Submit an updated drainage report meeting current criteria

FINAL DRAINAGE REPORT

FALCON ACRES SUBDIVISION

JPS Project No. 020506

FIGURE A2

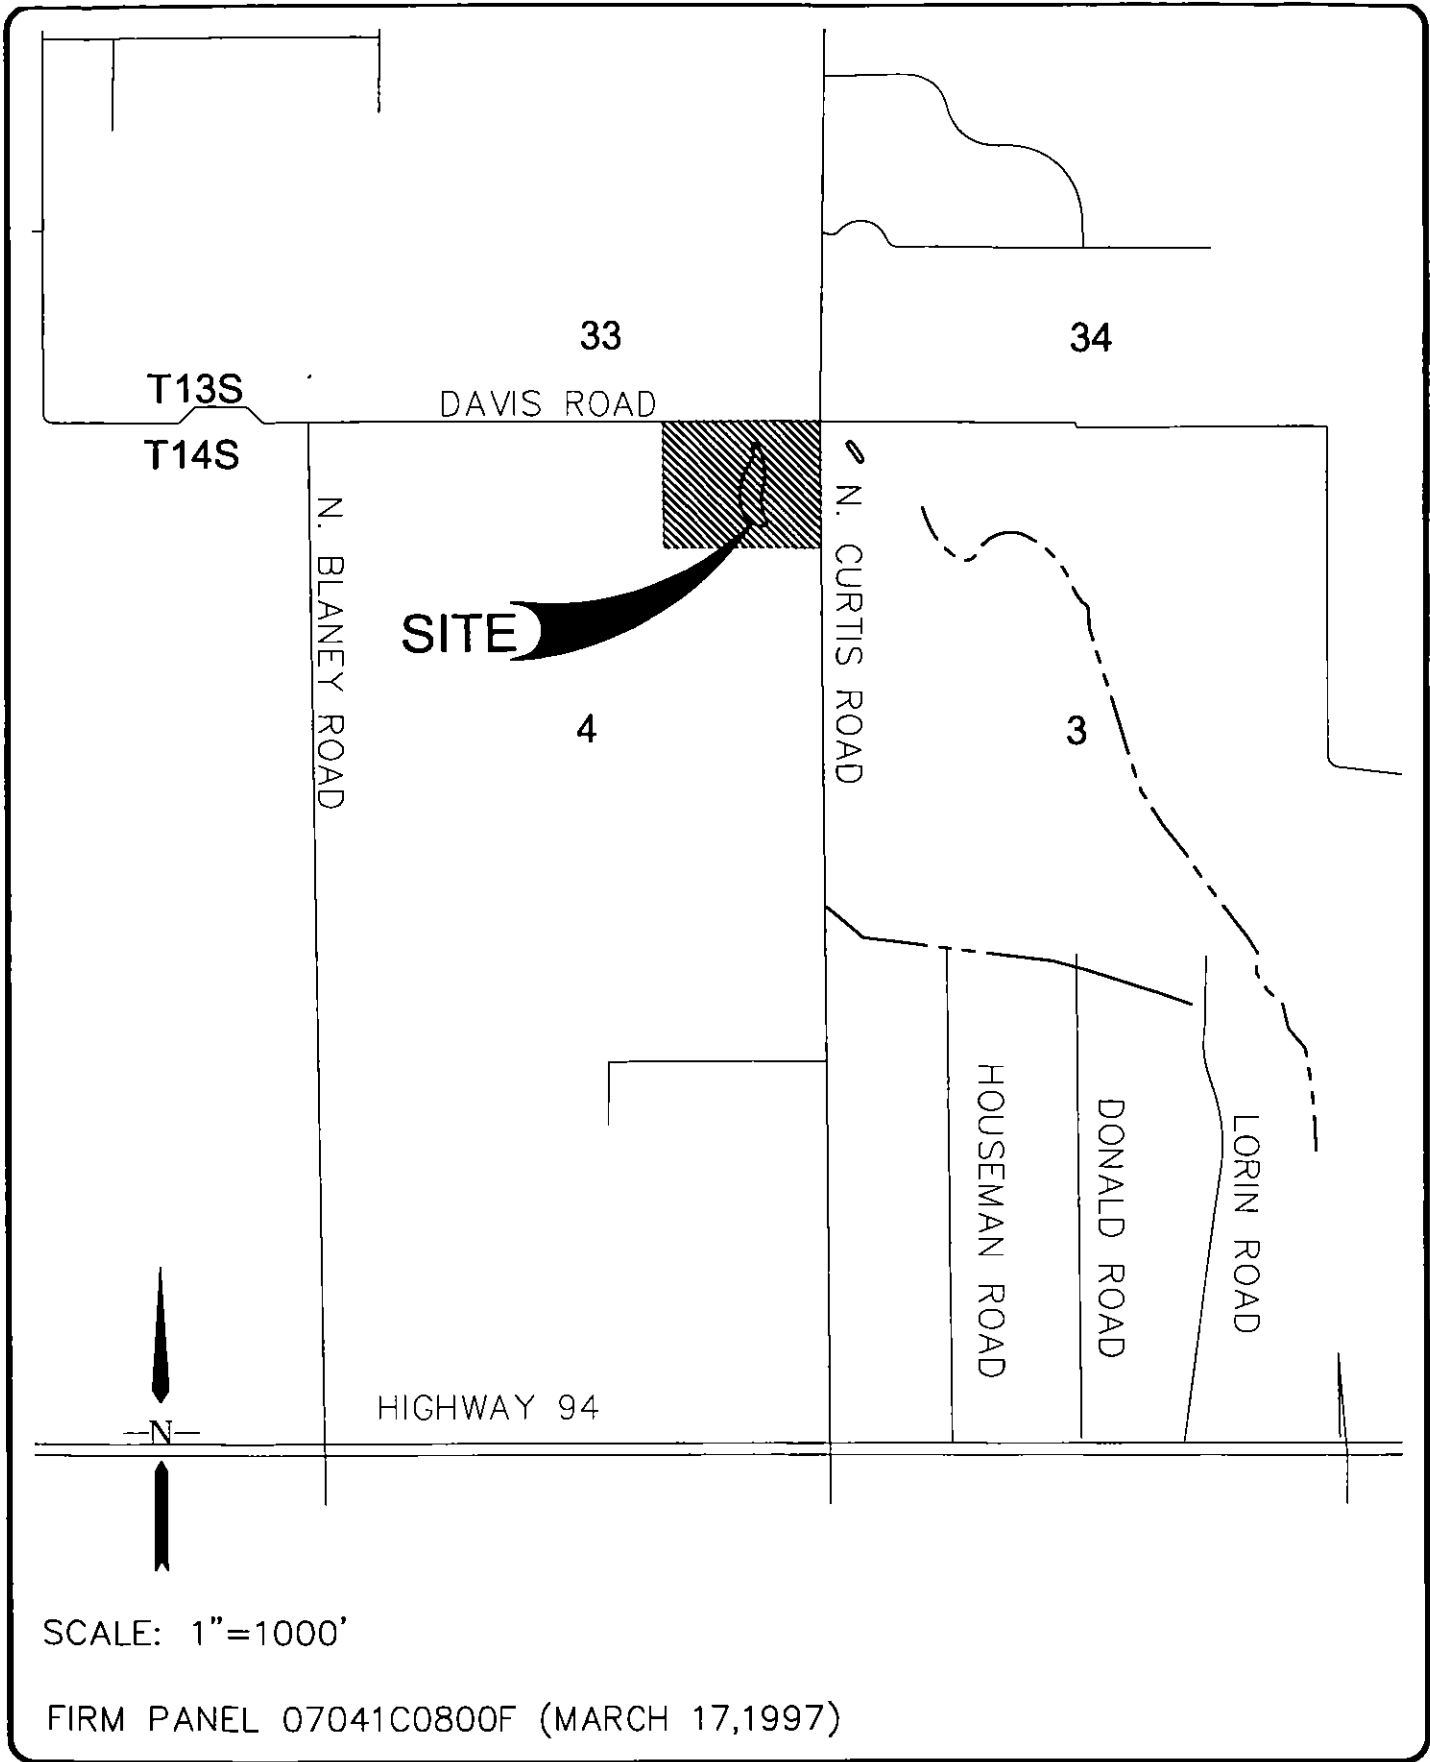
Update to the current effective FIRM

FIGURE 3-2. ESTIMATE OF AVERAGE FLOW VELOCITY FOR USE WITH THE RATIONAL FORMULA.

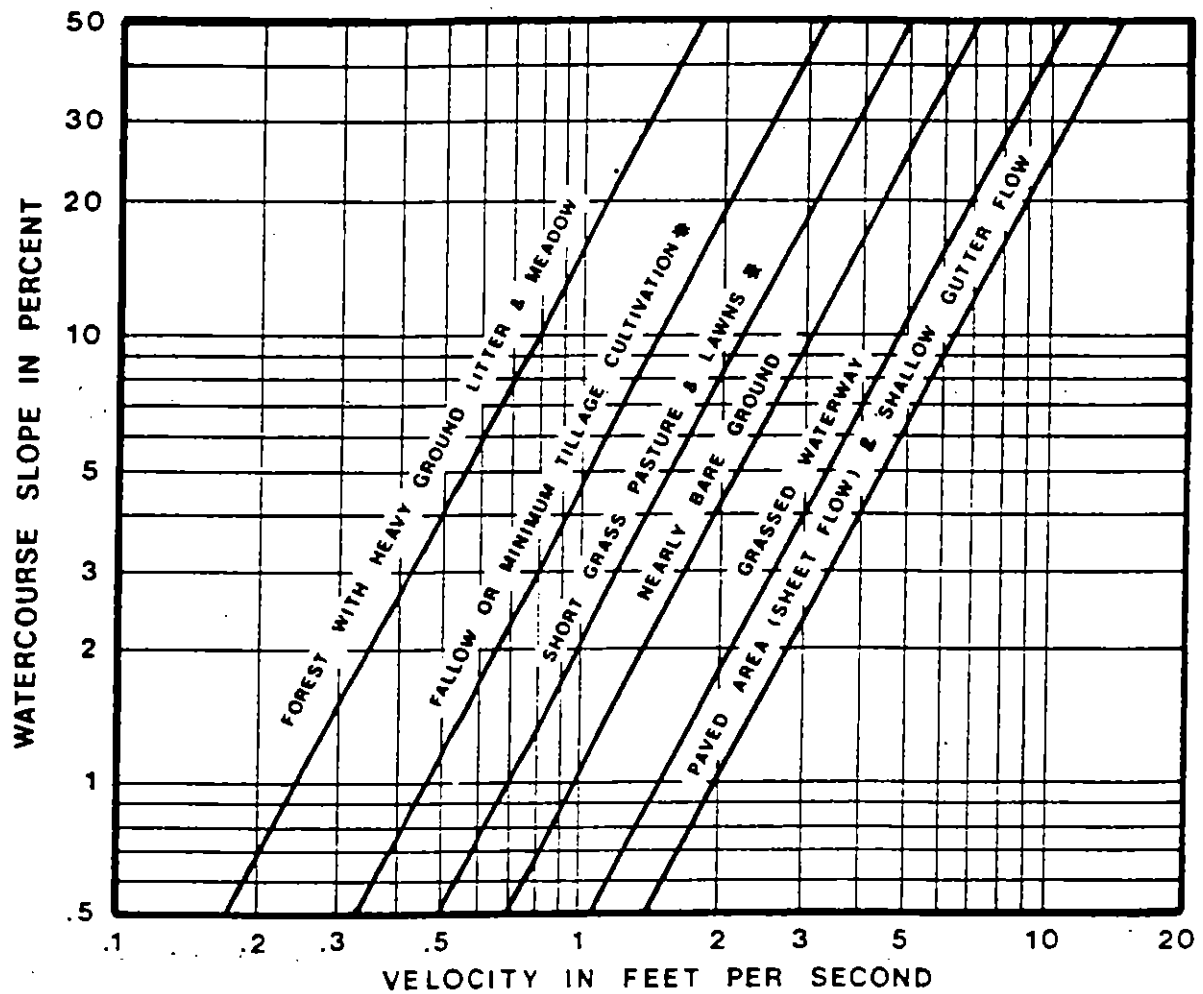
Replace with current criteria

FIGURE 3-2. ESTIMATE OF AVERAGE FLOW VELOCITY FOR USE WITH THE RATIONAL FORMULA.

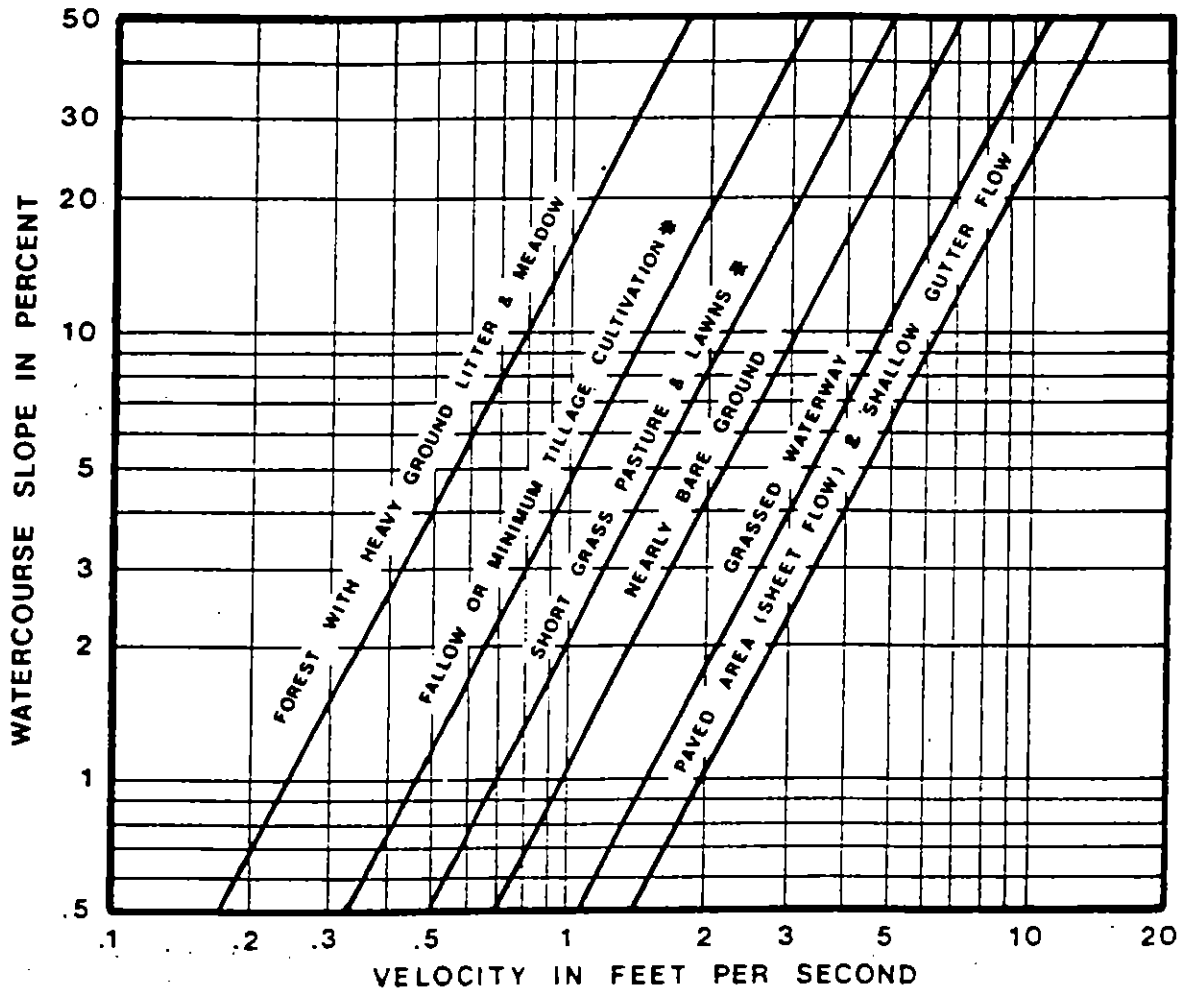
Replace with current criteria

FIGURE 5-7. RIPRAP EROSION PROTECTION AT CIRCULAR CONDUIT OUTLET.

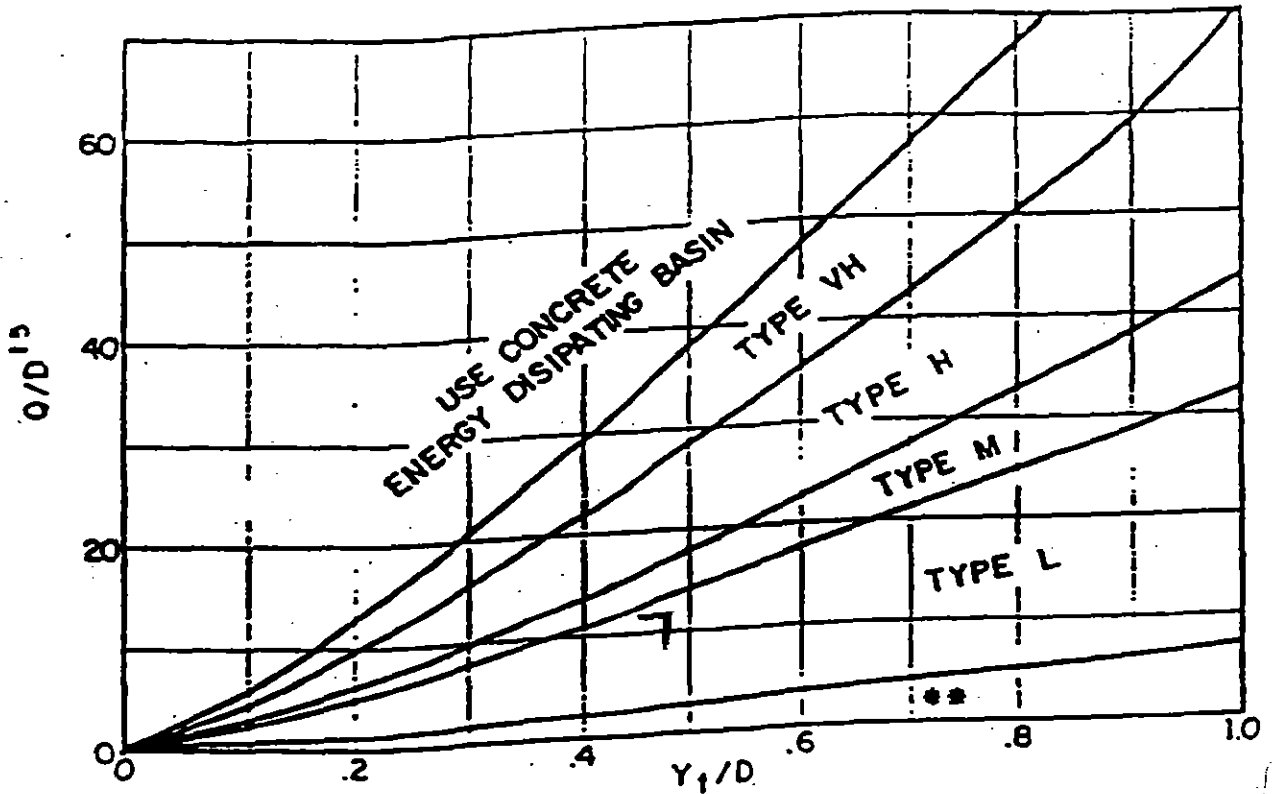
Replace with current figure. typ all
